December 3, 2002

SUBJECT: Calvert Cliffs Nuclear Power Plant
Unit Nos. 1 & 2; Docket Nos. 50-317 & 50-318
Response to Request for Additional Information, Generic Letter 96-06

SERVICE WATER SYSTEM SIMPLIFIED ELEVATION SKETCH

Service Water System Simplified Elevation Sketch

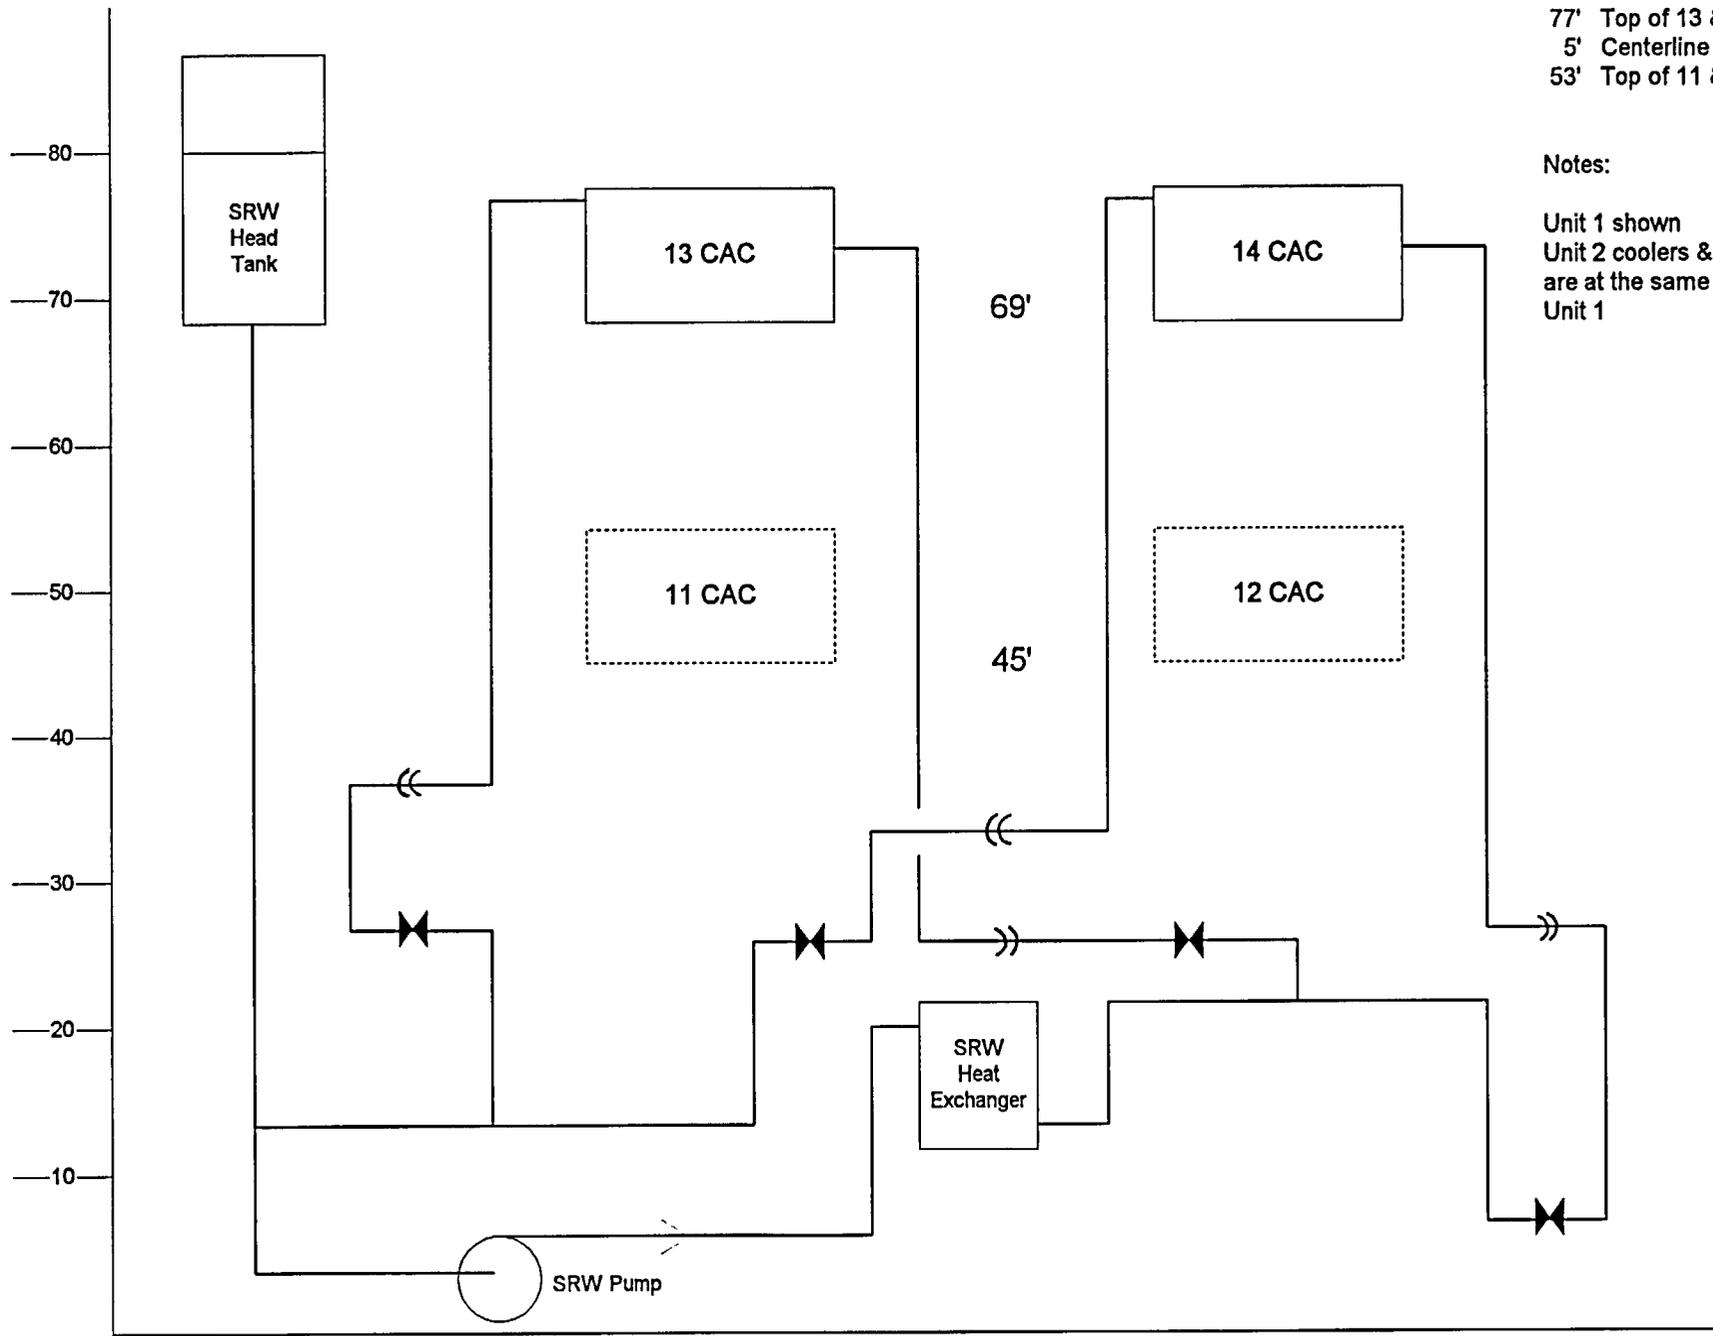
1. On July 25, 2002 (Reference f), Calvert Cliffs stated that waterhammer is the only remaining issue and several options to resolve it were being considered. Please provide a description of the option chosen.
2. Please provide a simplified elevation diagram showing the relative position of the service water (SRW) head tanks and the containment air coolers (CAC).
3. Please provide a discussion of the Generic Letter 96-06 worst case scenario as it applies to Calvert Cliffs.
4. Please provide a discussion of minimum margin to boiling in the SRW System with assumptions used in making this determination.
5. Please provide the results of the two-phase flow evaluation for the service water system.

The elevation drawing is attached to this letter.

At Calvert Cliffs the SRW flow is throttled on the inlet side of the CACs. There are no flow restrictions downstream of the CACs that would act to force the fluid closer to two-phase flow conditions. The piping at the outlet of the CACs drops off significantly in elevation resulting in pressure recovery, moving further from saturation conditions. Therefore, during the worst case loss-of-coolant accident conditions, the location to create two-phase flow conditions is situated at the outlet of the highest CAC.
